Product Change Notification

Change Notification #: 111732 - 01
Change Title: Intel® RAID Maintenance Free Backup Unit
AXXRMFBU2
PCN 111732-01, Product Design, Label
Add a Label to RMFBU2 Cache-offload
Module Cables
**Reason for Revision: Cancellation of changes
and Earlier Implementation**
Date of Publication: October 12, 2012

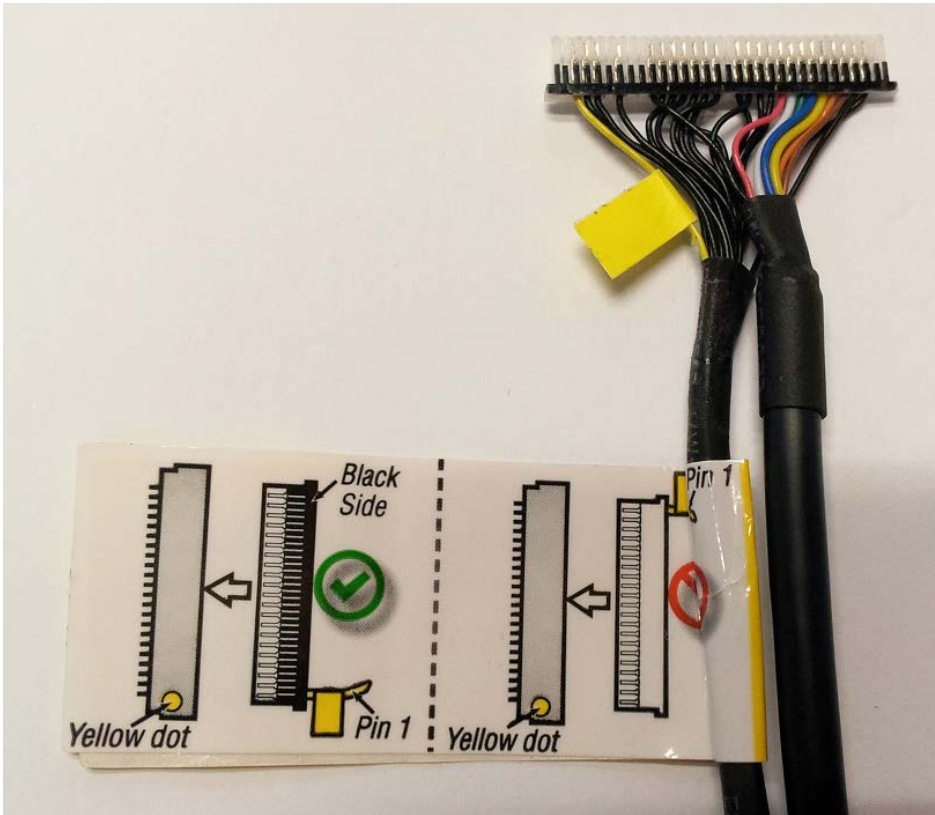
1. The RMFBU2 Cache-offload Module cables are updated with a label at both ends of the cable, in order to warn the user to connect Intel® Integrated RAID Module in the correct manner. Incorrect connection may damage the Intel® Integrated RAID Module and Intel® Maintenance Free Backup Unit AXXRMFBU2. The following are sample pictures of the new labels.
